Limited Expert Review of Probably Hydrologic Consequences and Ground Water Model Reports for Bull Mountain Mine Number 1 - AM6

Dr. W. Payton Gardner

Date: 7/12/24

To: Mr. Shiloh Hernandez – Earth Justice

Figure 1 - Estimated drawdown from a single pumping well in the center of the mine permit area at a radius of 2.5 miles, pumping at 6 gpm. Median, 10th and 90th percentile of simulated drawdown from 1000 realizations of aquifer parameters based upon field characterization data.

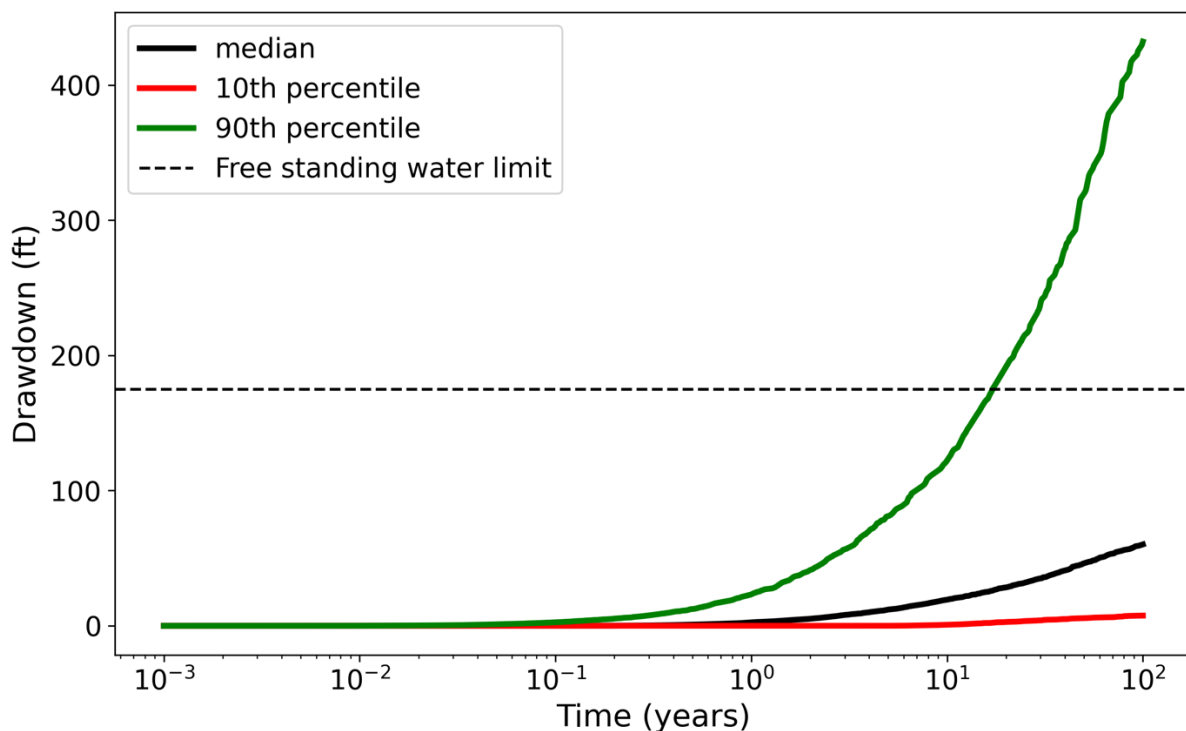
Given the already observable and likely impacts from mining on shallow aquifer systems, the PHC states without any quantifiable calculations that underburden aquifer in the Sandstone UB2A is an adequate reservoir to supply all mitigation water in the area. Whether or not this aquifer could supply the needed mitigation water is an important question, which is not addressed in the PHC. These sandstones were deposited in a fluvial environment, tend to not be laterally extensive, and are highly heterogeneous (Thompson, 1982). Initial calculations from a well contractor, using a transmissivity that was deemed to be in error, and is one to two orders of magnitude higher than the accepted transmissivities given in the PHC, indicate that even using this artificially high transmissivity, observable drawdown would be seen at the nearest private well in less than a year (Hydrometrics, 2009). No drawdown calculations were made in the PHC at all with the current accepted transmissivities. In addition, the effect of heterogeneity, and the strong likelihood that the aquifer has a large range of transmissivities is completely ignored. As an example calculation, which incorporates the current reported hydraulic conductivity, thickness and specific storage data (GWR) and attempts to characterize the uncertainty given expected heterogeneity, I have predicted the drawdown in a confined aquifer using 1000 different realizations of aquifer parameters (hydraulic conductivity (K), specific storage (S_s) and aquifer thickness (b)), drawn from statistical distributions fit to the data for sandstone UB2A presented in the GWR. Here hydraulic conductivity and specific storage are assumed to come from lognormal distributions and aquifer thickness to come from a gamma distribution all fit to the data given in the GWR. Drawdown is calculated using the Theis method (Theis, 1935), a standard solution for estimating drawdown in a confined aquifer, where the aquifer transmissivity $T = Kb$ and storativity $S = S_s b$ for each realization are calculated from a random draw from the fitted distributions. The median, and 10th, and 90th quantiles of all simulations for drawdown at the mine boundary (2.5-mile radial distance) due to a single pumping well in the center of the mine, pumping at 6 gallons per minute, is shown in Figure 1. The median drawdown for all realizations, which is representative of the most likely outcome is 60 ft after 100 years. The 90th percentile, which is representative of the upper bound of what could be expected, shows the drawdown at the boundary reaching the reported height of freestanding water above the aquifer within 10 years. The 10th percentile drawdown, which is representative of the minimum amount of drawdown expected at the boundary is around 7 feet at 100 years, *from a single well pumping at 6 gpm*. It is important to note that drawdown at smaller radii will be higher, drawdown will increase if the pumping rate is increased, and the adding more pumping wells will also increase the drawdown.

Current mine drainage from shallower groundwater is around 1000 gpm, and model forecasted drainage is over 800 gpm for over 50 years (Water and Environment Technologies, 2024b). If even a fraction of this drainage water needed to be mitigated, far more the 6 gpm will need to be pumped from the sandstone aquifer. Given this probabilistic analysis of drawdown from a single well, and the fact the mitigation water could be needed for many shallow groundwater wells and springs due to mining it is highly unlikely that the lower aquifer can be expected to supply more than a few pumping wells at all, and very unlikely mitigation would occur without very significant adverse effects to existing users of this aquifer both within and outside of the mine boundary. The PHC simply states that this confined sandstone has adequate water, without any quantifiable calculation, which is not scientifically justifiable, and likely incorrect.
